## [Braddock Road Meeting](#) Notes 20221129 - A few highlights relevant to Accotink Creek

**Selected Presentation Slides:**

## Critical Intersection – Danbury Forest / Wakefield Chapel Option 1

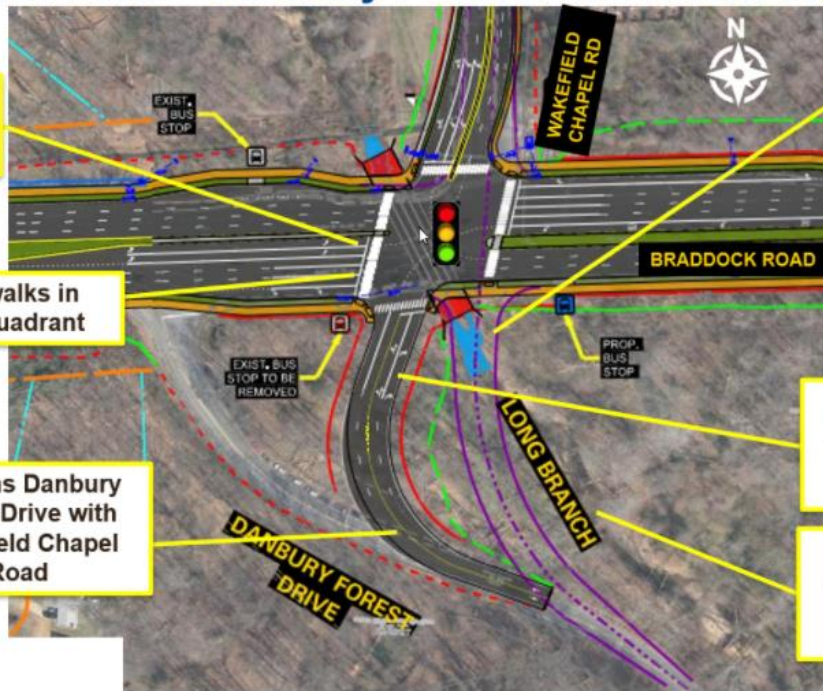
Greater tree, stream, and wetland impacts than other options

*Option 1 – A traditional road configuration popular with the public, but harmful for the watershed  
This option to realign both street and stream is still dead, but many residents seem to be applying CPR.*

## Critical Intersection – Danbury Forest / Wakefield Chapel Option 2

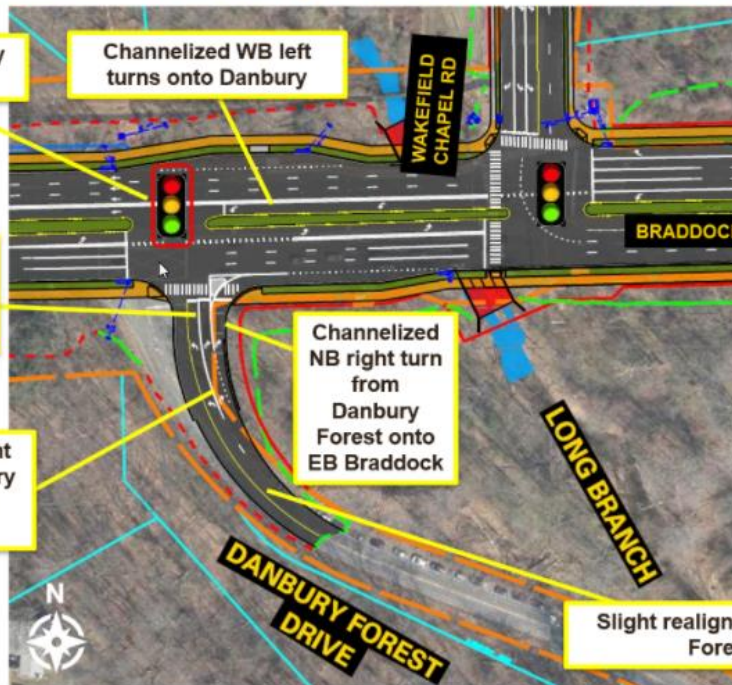
*Option 2 – Unloved by all, but second-best for the environment among official options*
